**Ref: ABP-313059-22**

## **INTRODUCTION**

South Dublin County Council hereby sets out its Chief Executive's Report, including recommendations on the above Strategic Housing Development for An Bord Pleanála (ABP or The Board). The Board as the competent authority has validated the application, and will carry out an Appropriate Assessment Screening of the proposed development, and will decide to grant or refuse permission for the proposed development.

See below tanks located within public open spaces areas as identified in the submitted drainage layout drawings;

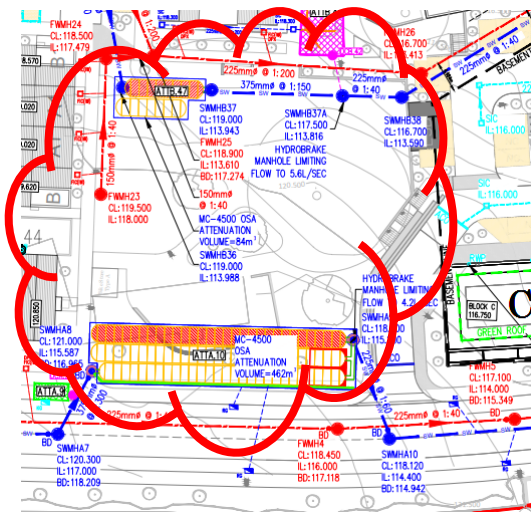
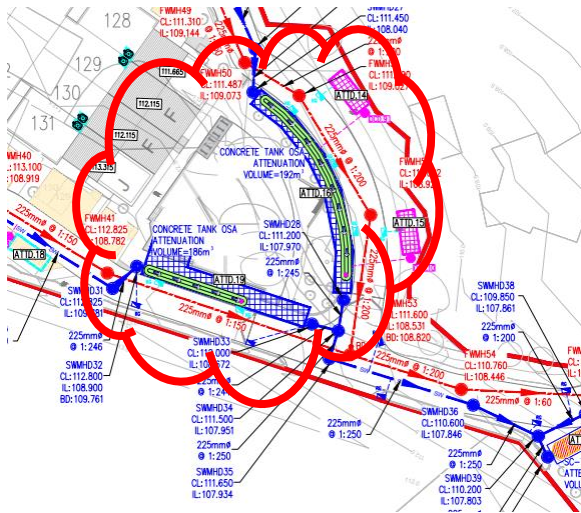
There appears to be a disparity between the proposed SUDs and attenuation tanks layout proposed as part the surface water drawings and the surface water and SUDS layout proposed with the Engineers Services Report.

Engineering Services Report prepared by CS Consulting states that “Due to the topography of the site and constraints owing to existing trees to be retained, the storage has been provided by means of Stormtech attenuation systems, Aquacell crates below permeable paving, tree pits and bio retention areas, Aquacell crates in open areas that will not be offered for taking in charge and an RC tank below basement level for catchment C”

*Figure 1 Road's layout identifying possible links to other developments.*

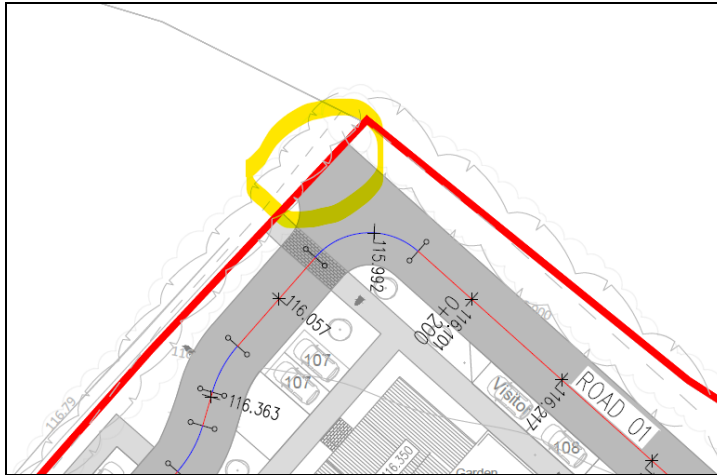
**Masterplan. A reasonably detailed block design of the remaining phases is required to ensure the road layout and hierarchy is optimal for the entire Masterplan.”**

The applicant has submitted an indicative roads layout masterplan of the surrounding zoned lands. The layout identifies links to other future developments, and pedestrian/cycle routes within the development. The detail of this proposal is limited and does not fully convey the overall development proposal.
